# UPGRADE RPG HARDWARE FOR FUTURE DIGITAL OR FRAME RELAY COMMUNICATIONS

## DOPPLER METEOROLOGICAL RADAR WSR-88D

Upgrade Radar Product Generator (RPG) Hardware for Future Digital or Frame Relay Communications.

This routine modification provides hardware installation instructions to upgrade the RPG for future implementation of digital or frame relay communications. The authority for this modification is Radar Operations Center (ROC) Engineering Change Proposal (ECP) 0177, Upgrade RPG for Digital or Frame Relay Communications.

Figure 1. Router Location

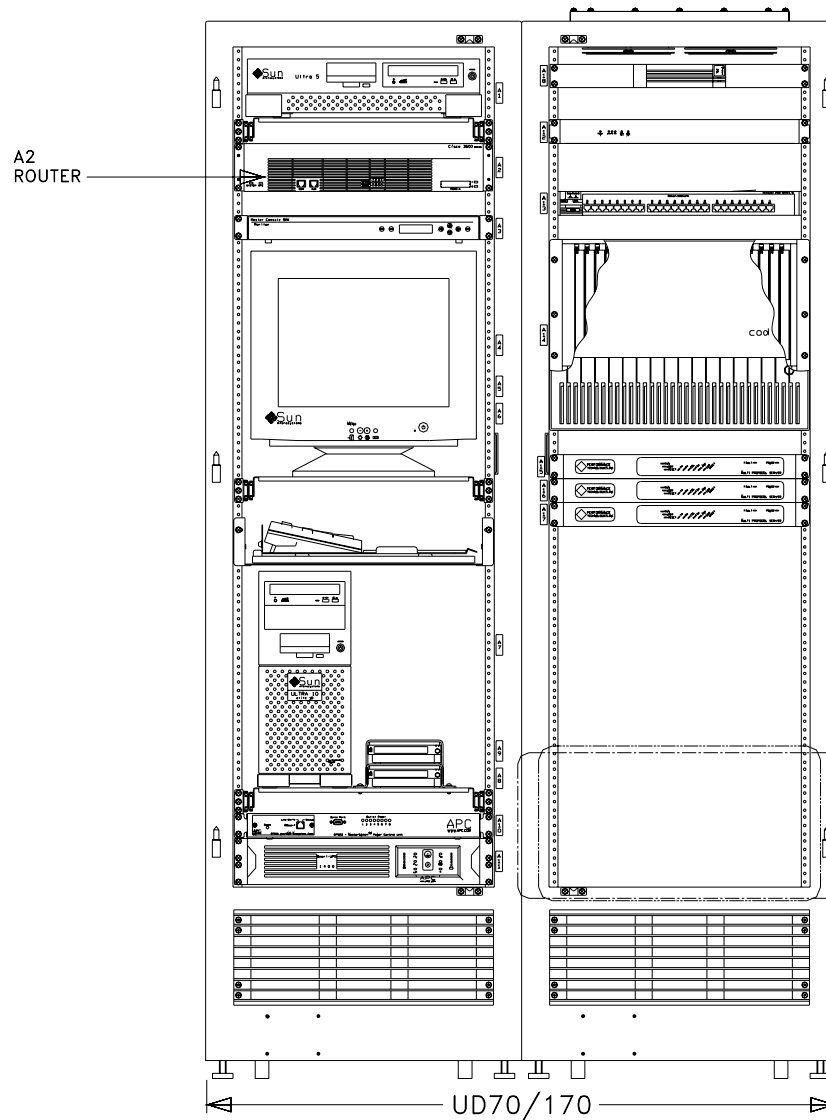
- e. Click on the **Close** button to close the *Console Messages* window.
2. Open the RPGPCA cabinet doors and locate the Router UD70A2. (Refer to [Figure 1](#) for router location.)

Figure 2. Router Module Location

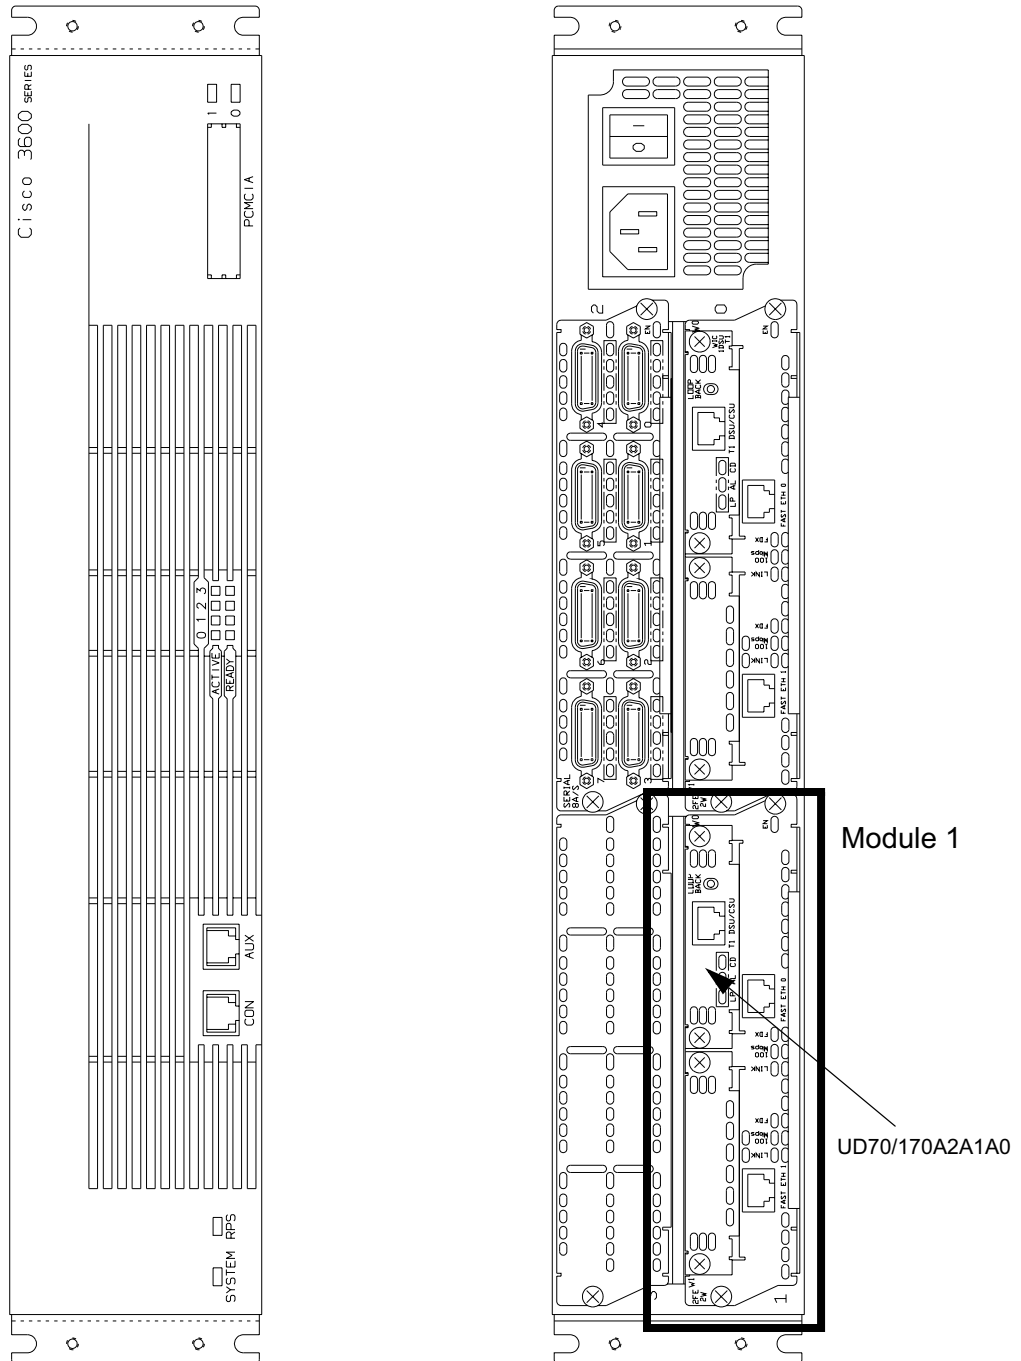
1. Put the ESD wrist strap on bare wrist and connect clip the lead to the chassis frame or proper ground.
2. Locate the modules installed in the back of the Router UD70A2. (Refer to [Figure 1](#) for the router location, and [Figure 2](#) for the router module locations.) Module 0 (UD70/170A2A1A0) is the bottom right module. Module 1 (UD70/170A2A1A1) is the bottom left module. The module number is engraved on the router case and may be difficult to see.

3. On Module 1 (UD70/170A2A1A0) on the back of the router:
  - a. Loosen the captive screws that hold the blank filler panel installed in Network Module Slot 1.

- e. Remove the screws that hold the blank filler panel for WAN interface card slot W0 installed in Network Module Slot 1 of the two port Ethernet module and remove the metal covering plate.

- i. Connect the male end of the surge protector (P1 equipment port) to the WIC port.
- 4. Connect the female end (P2 line port) of the surge protector (E2) to 70/170W261 (the 10' patch cord) P2 end.
